**ADDENDUM NO. 2**  
**May 18, 2018**

Maintenance Building  
Webster Office Complex  
Day County, South Dakota  
GFP Project No. Webs18Wa

## ELECTRICAL POWER PLAN

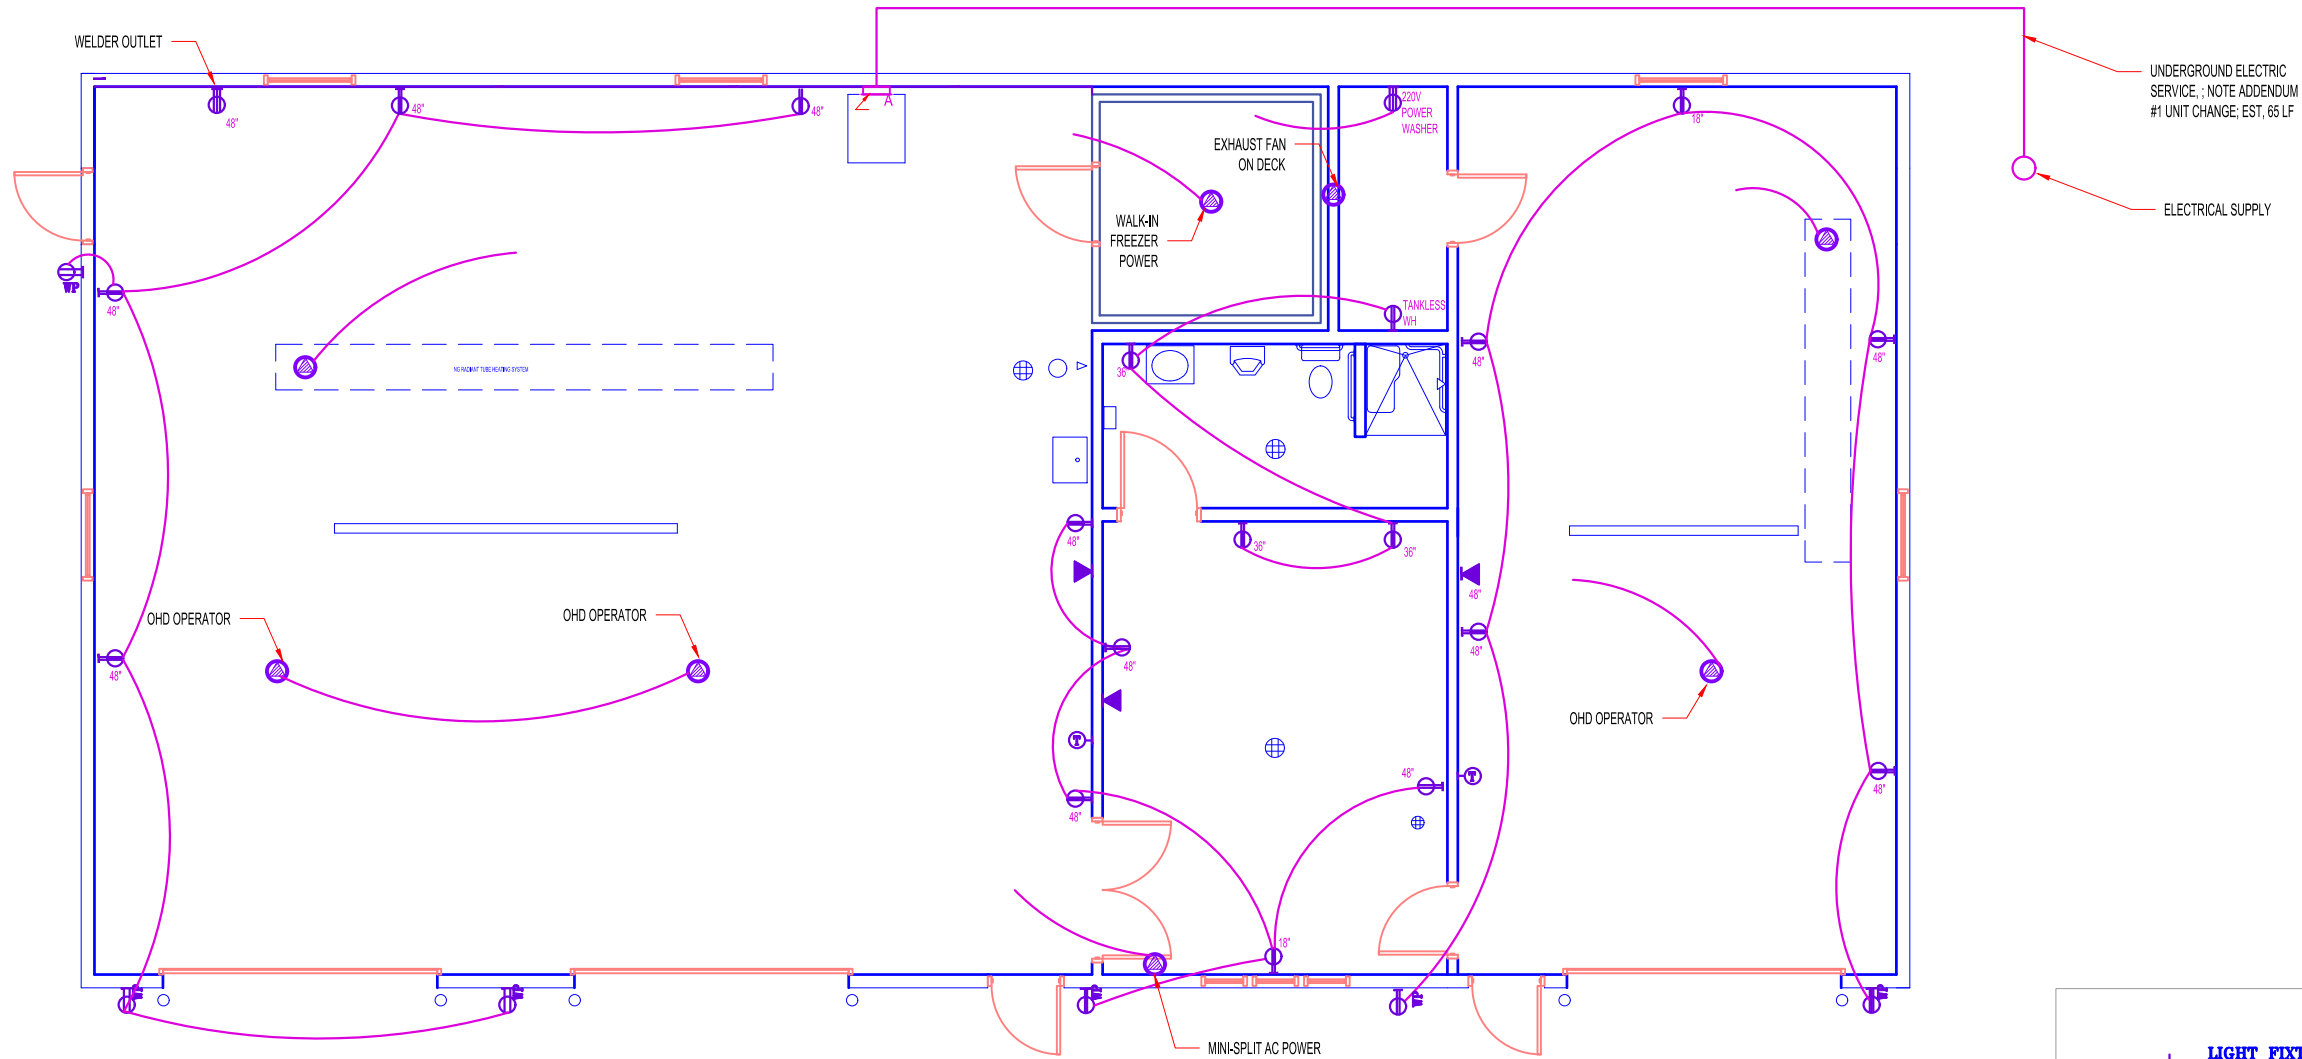
- Item No. 1: Change to Panel "A" Layout on Sheet E1: See Attached Plan Sheet
- Item No. 2: Change to Electrical Outlet Layout: See Attached Plan Sheet
- Item No. 3: CLARIFICATION: Underground Electrical Service Layout: See Attached plan Sheet
